Town of Dover Planning Board

Planning Board Special Meeting
Monday , December 3, 2012
7:00PM

PLANT LIST SHEET L 1

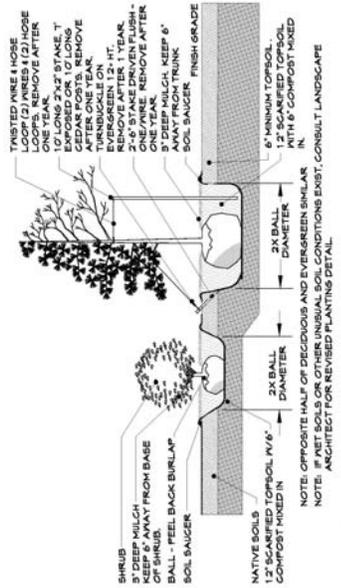
Peter Muroski- I think she has a great plan- if we are going to be purists, you may want to think about changing the Stella d'Oro Daylily to Heliopsis or Rudbeckia and I'm a big fan of the Shasta daisy but if you wanted to be more of a purist - New England Astor or a White Woodland Aster. The Arborvitae are ok but again if you want to use a native plant- nigra might be a better fit. I'm also a big fan of the White Spruces- they are more dense and the deer don't eat them.

Member Muroski- Yes they would get thicker, provide a better screen and you probably won't have to plant them so close. The Double Flowering Weeping Cherrys are fine- but the malus Adirondack we seem to be using those more, instead of calapy pears. Your choices of plant are just fine, these are just suggestions.

Chair- Would it be better to stagger the planting give them more space to grow?

Planner Ley- The sidewalk between lots 3 & 4 was left off the plan that should be added.

A: Yes they can be staggered, the spruces seem to have a different habit than the arborvitae, I just don't want to use up too much of the yard space, I wanted to keep it nice and open for playing, etc. They can be staggered though, and we can give more space for each plant to grow.
